New Sixth Appellate District Courthouse Project

FINAL Environmental Impact Report

SCH Number 2024040386

Prepared for: Judicial Council of California

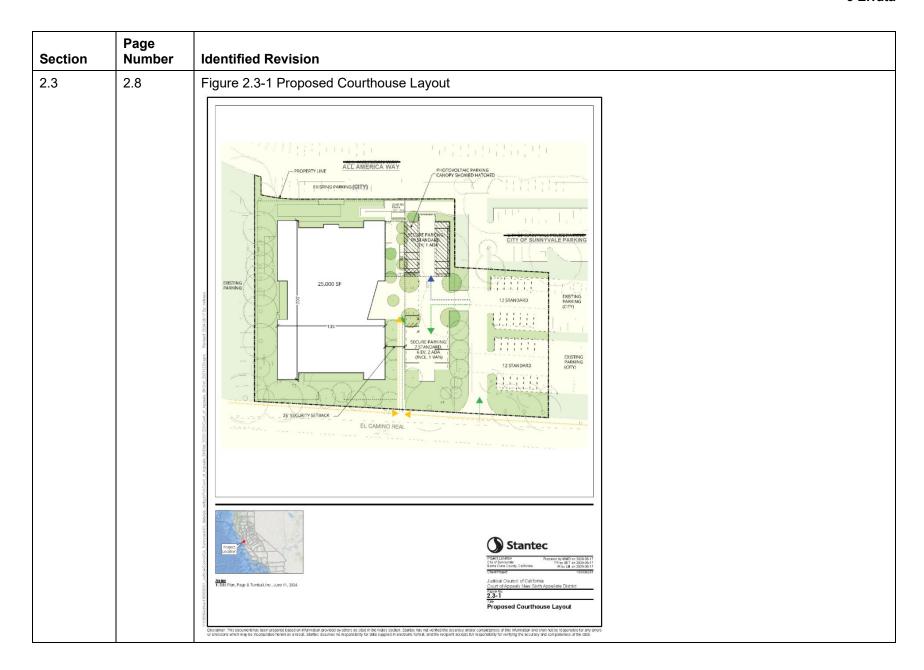
L2-10 Comment: d) The label for "All American Way" should be changed to "All America Way."

L2-11 Comment: e) The label for "City of Sunnyvale Police Parking" should be updated to only "City of Sunnyvale Parking."

L2-12 Comment: f) For the existing parking shown north of the proposed courthouse building, update the label to, "Existing Parking (City)."

Response: Figure 2.3-1 Proposed Courthouse Layout has been updated from "All American Way" to "All America Way". Updates have been integrated within the FEIR as indicated in Chapter 3 Errata.

Response: Figure 2.3-1 Proposed Courthouse Layout has been updated from "City of Sunnyvale Police Parking" to "City of Sunnyvale Parking". Updates have been integrated within the FEIR as indicated in Chapter 3 Errata.

Response: Figure 2.3-1 Proposed Courthouse Layout has been updated to include (CITY) to the "Existing Parking" to the north of the proposed courthouse building. Updates have been integrated within the Final EIR as indicated in Chapter 3 Errata.
